This Service Information bulletin supersedes SI B12 14 12 **dated August 2013.**

N51, N52K, N52T and N55 Engine: Various Faults Stored in DME Related to VANOS and Camshaft Position

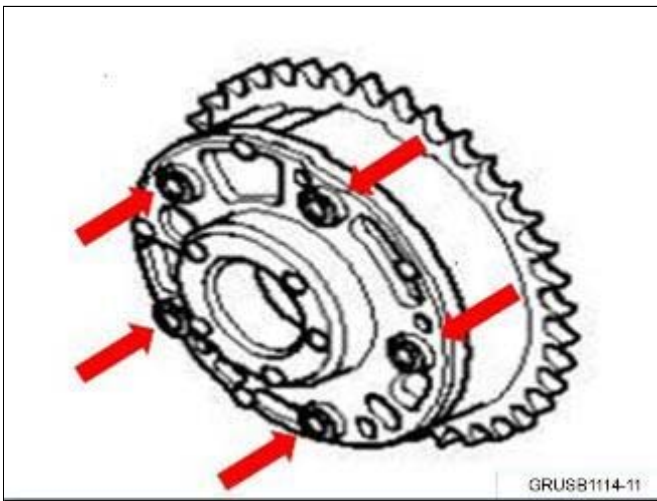
One or both (intake and/or exhaust) of the VANOS gear assemblies have faulty assembly bolts. One or more of the five assembly bolts have loosened or broken. The location of these bolts is shown in the illustration below:

1. Replace **both** VANOS gear assemblies. Refer to Repair Instruction 11 36 046, "Removing and installing or replacing intake and exhaust camshaft units."
2. If the bolts have been found broken, the missing portions of the bolts will need to be retrieved from the engine before the final repairs are made. This additional work may include removing the engine oil pan, and a close examination of the timing chain drive to retrieve the missing parts. Refer to the applicable repair instructions for oil pan removal procedures.
